Proposal for Supplement 4 to the 03 series of amendments of UN Regulation No. 26 (External projections of passenger cars)

The text reproduced below was prepared by the expert from OICA to amend the provisions for rear edges of the bonnet. The modifications to the current text of UN Regulation No. 26 are marked in bold characters.

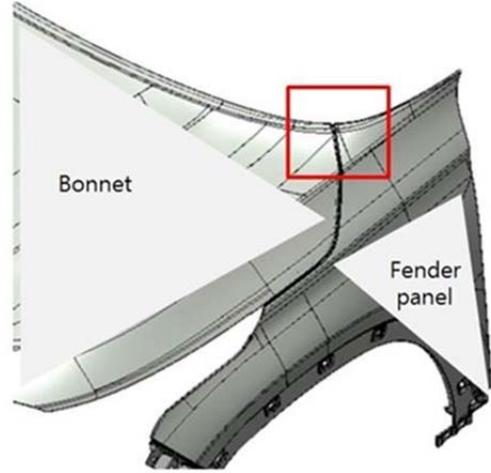
The rear edge of bonnet includes the extrapolation of this edge to the left and right (e.g. as upper edge of the fender or as edge of the a-pillar) and other inward facing edges of body panels not easily contacted by vulnerable road users may be blunted."

This justification is valid in the same way for rear edges of fenders or rear edges of A-pillars if they are extended from the rear edge of the bonnet to the left and to the right.
